Foxground and Berry bypass

Princes Highway upgrade

Submissions report

MAY 2013

Figure 3.3 Property access at chainage 12850

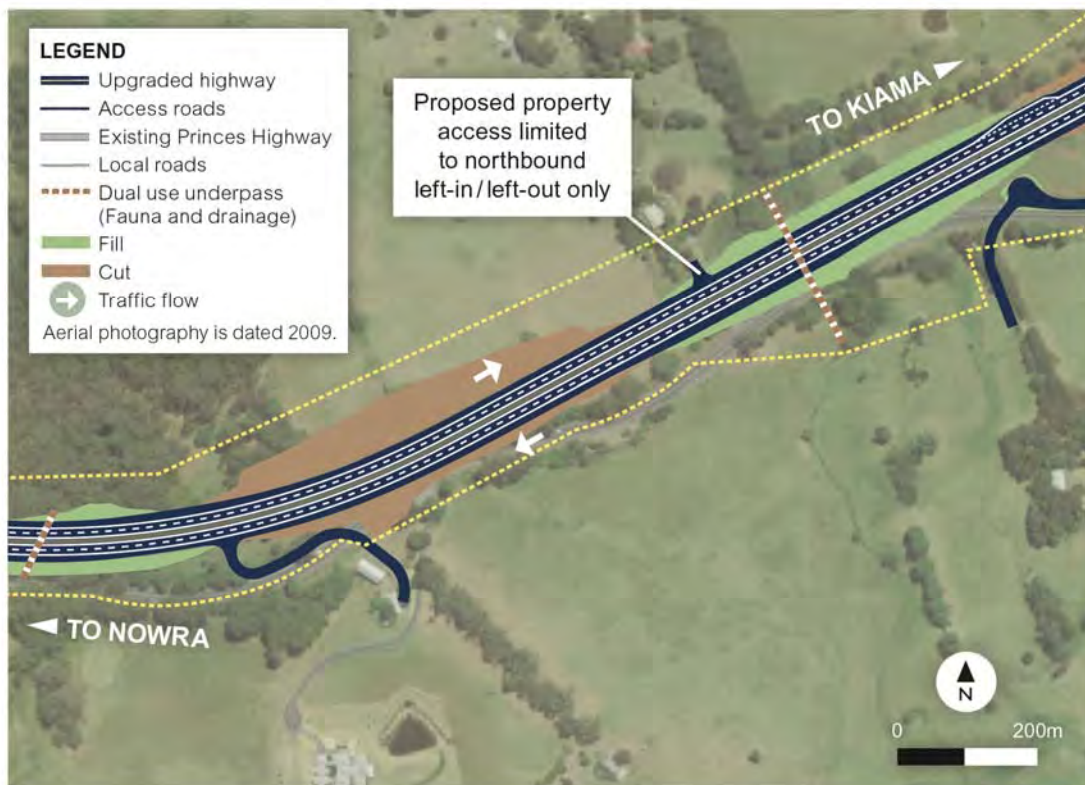
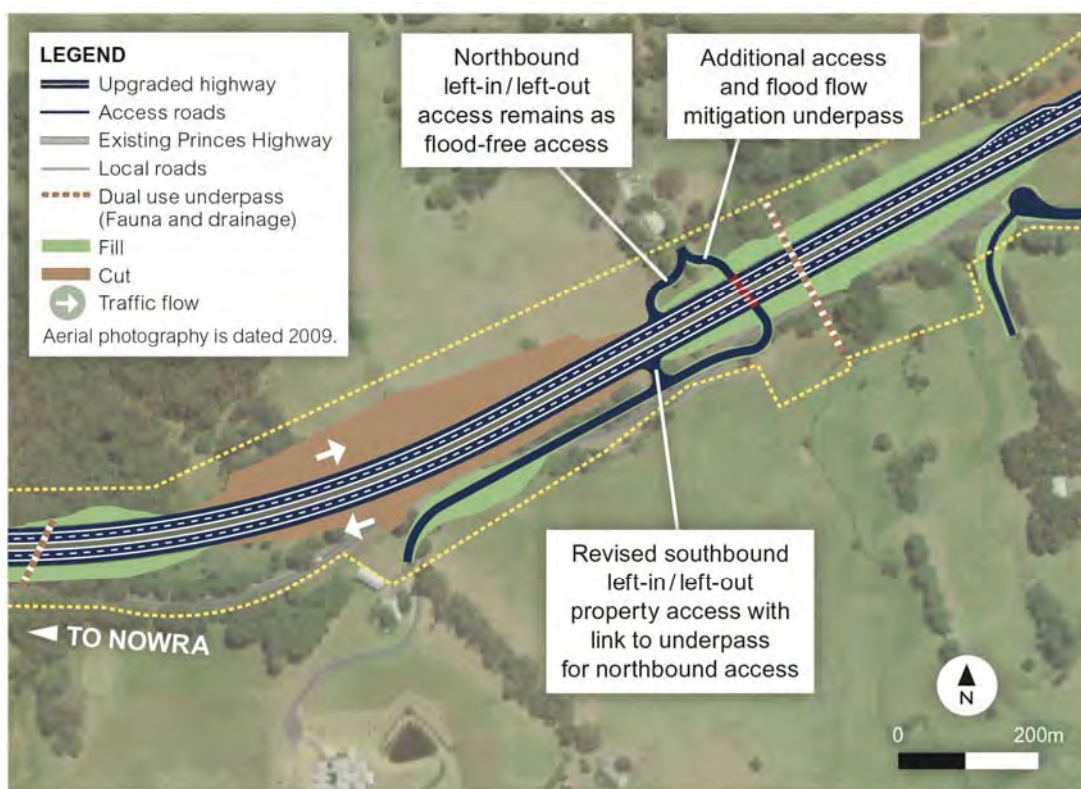
In response to issues raised following exhibition of the environmental assessment as discussed in **Section 2** of this report, RMS has revised the design for a property access at Chainage 12850. The design presented in the environmental assessment included a left-in / left-out only access driveway at about Chainage 12890, about 550 metres south of the Austral Park Road interchange and a combined drainage and fauna underpass culvert about 80 metres north of this, at about Chainage 12810. The original access design is shown in **Figure 3.3**.

The revised design has been developed in consultation with the property owners and now provides two property accesses at this location. The existing proposed left-in / left-out driveway would remain and an additional underpass connection to the eastern side of the project would also be provided. The large fill embankment required at this location enables the underpass to be included without significantly affecting the main alignment. The new underpass would provide flood flow relief in the event of culvert blockage or overflow in large rainfall events and alleviates concerns that the road embankment would affect flooding on the property. The left-in / left-out driveway would provide flood free access in the event that the underpass is unusable in large rainfall events.

In addition to alleviating potential flood impacts, the inclusion of the new underpass reduces the travel time required for the affected property to access the project and travel southbound. It provides an opportunity to link to a property on the eastern side of the project and reduce the travel time required to access the property from the south and reduces travel time for southbound access for a property immediately to the north as discussed in **Section 3.4.2** of this report. The proposed design is shown in **Figure 3.4**.

Figure 3.5 Gembrook Lane intersection

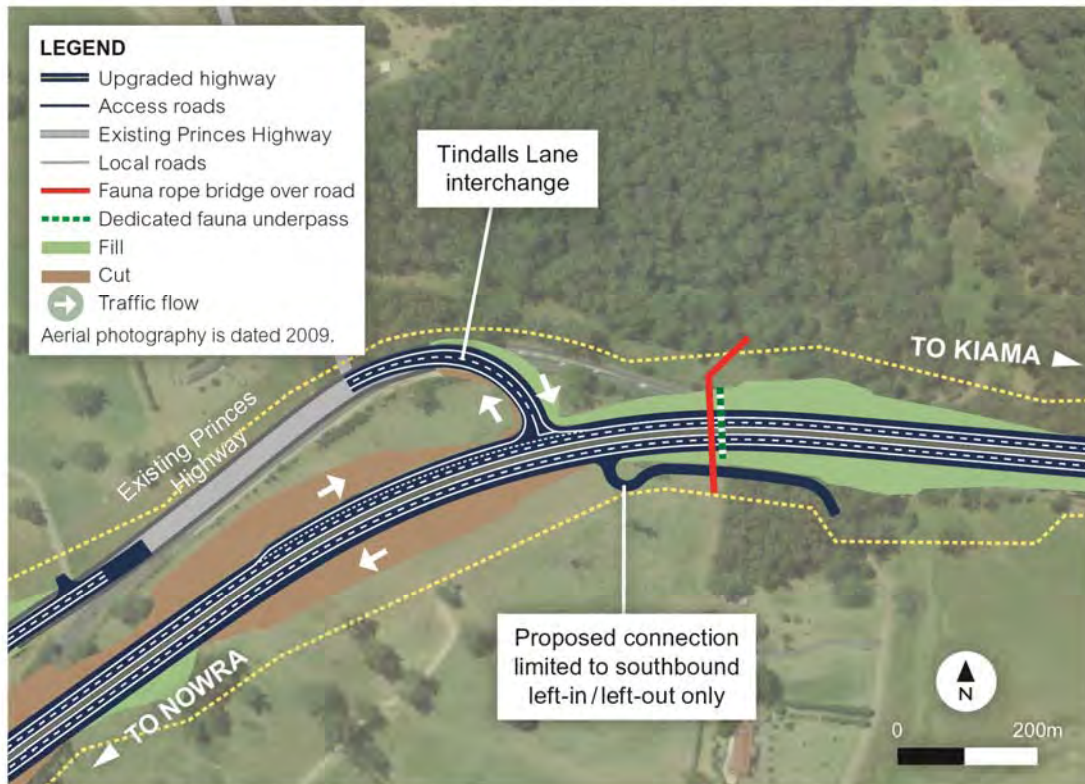
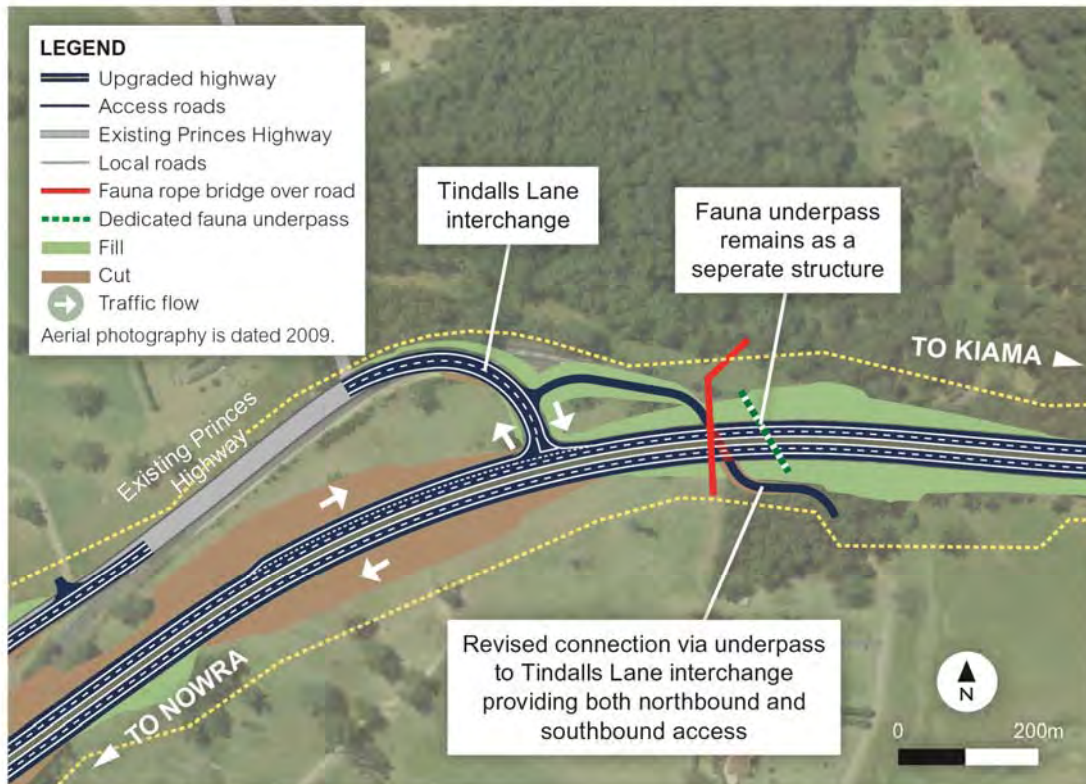
The design for the Gembrook Lane access presented in the environmental assessment consisted of a left-in / left-out only junction at about Chainage 13770, opposite the Tindalls Lane interchange. Under the original design, property owners would be required to travel north to the Austral Park Road interchange and perform a u-turn in order to access Gembrook Lane from the south. The design included in the environmental assessment is shown in **Figure 3.5**.

The large fill embankment required at this location enables an underpass to be included without significantly affecting the main alignment. The proposed design is shown in **Figure 3.6**.

Figure 3.8 Town Creek diversion
Refined design (April 2013)

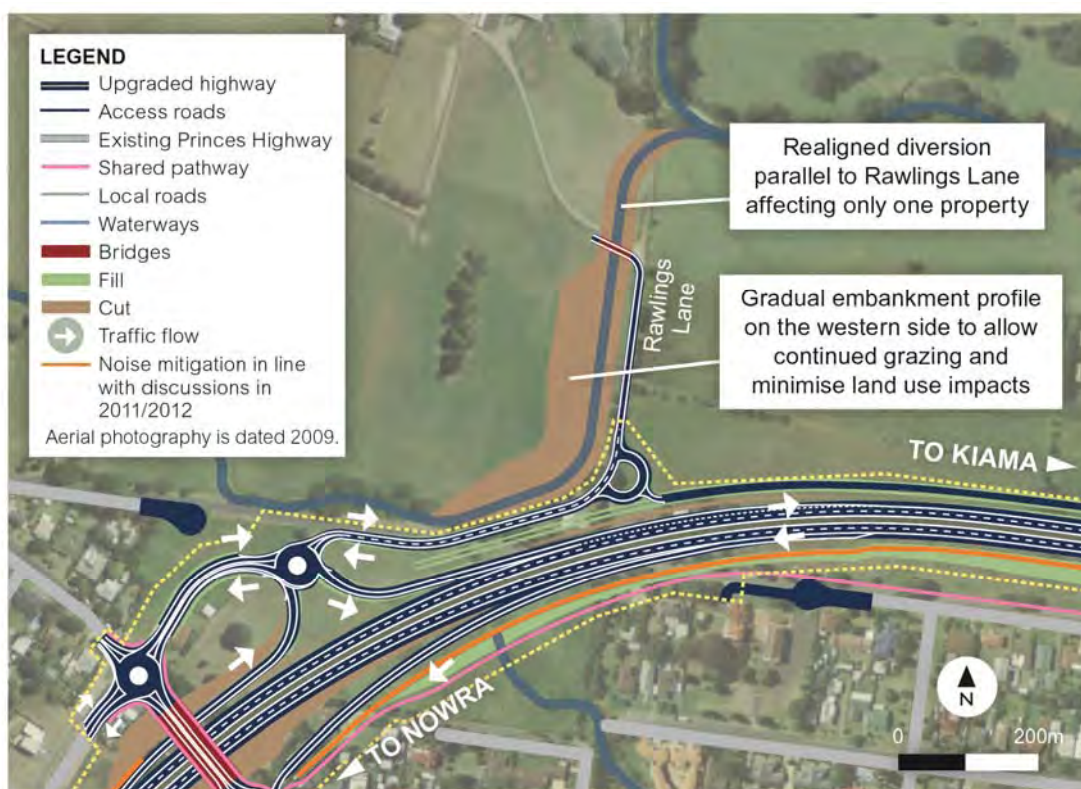
In response to issues raised during the environmental assessment as discussed in **Section 2** of this report, RMS propose to change the alignment of the Town Creek diversion in order to minimise potential impacts to existing farm operations for the affected properties. The design presented in the environmental assessment provided an alignment that starts at about Chainage 17450, to the north west of Kangaroo Valley Road and meanders across two properties and Rawlings Lane before entering Bundewallah Creek. The original design presented in the environmental assessment is shown in **Figure 3.7**.

The proposed new design includes a straighter alignment that is wholly contained in the property to the west of Rawlings Lane rather than affecting both properties. The new alignment would be contained within an easement to the west and parallel to Rawlings Lane and has been developed in response to consultation with the two affected property owners as the option that least impacts ongoing farming activities. The proposed design is shown in **Figure 3.8**.

Figure 3.12 Schofields Lane intersection
Refined design (April 2013)

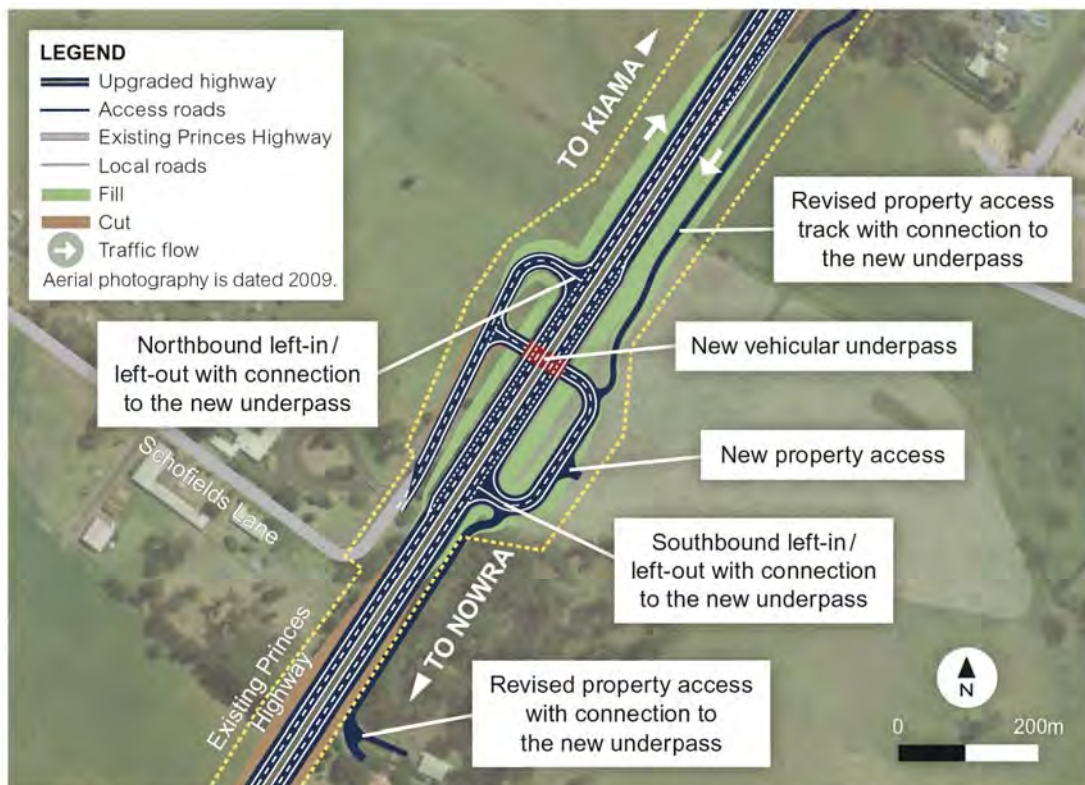
In response to the issues raised during the environmental assessment as discussed in **Section 2** of this report and as part of the development of the revised Victoria Street access arrangement, the design for the Schofields Lane intersection has changed to provide left-in / left-out access both northbound and southbound connected via an underpass. Property access roads connect to the intersection on the eastern side of the project. The intersection has also been moved 20 metres to the north to reduce property boundary impacts associated with its larger footprint.

During the development of the new design, RMS has considered the requirement to provide safe deceleration into the southbound junction. The component of the intersection on the eastern side of the project has been configured to allow sufficient space between the end of the southbound on-ramp from Victoria Street and an appropriate deceleration lane. The proposed design change for the Schofields Lane intersection is shown in **Figure 3.12**.
